**SERVICE BULLETIN**

**APPLICABILITY:** 2013-15MY BRZ

**NUMBER:** 12-191-15

**SUBJECT:** “Growling” Sound When Fully Closing the Door Glass

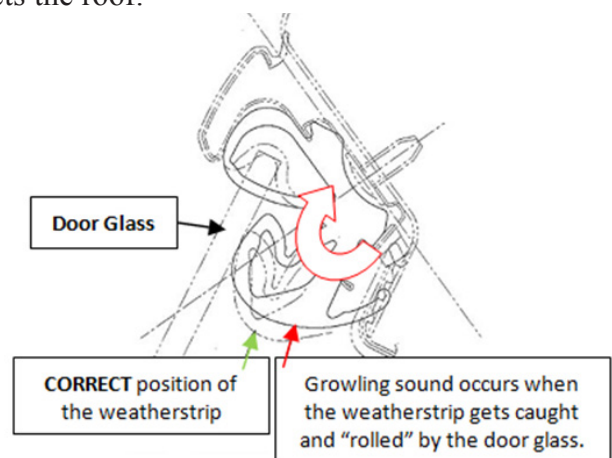
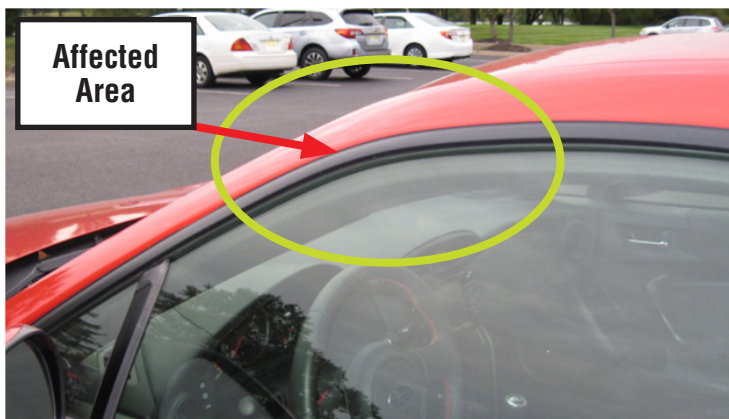
This bulletin announces a design change of the roof weatherstrip retainer/ molding to address customer concerns of a growling sound which may be heard when fully closing the door glass. The sound results from a deformation of the roof weatherstrip caused by the retainer/ molding. The retainer/ molding can cause the weatherstrip to “roll” as shown in the illustration below when the glass closes fully in the area where the “A” pillar meets the roof.

The new retainer/ molding assembly was incorporated into production starting with VIN **G\*600012**.

If the condition is verified as described above, replace the retainer/ molding assembly and roof weatherstrip **as a set** on the affected side of the vehicle following the procedure described in the applicable Service Manual.
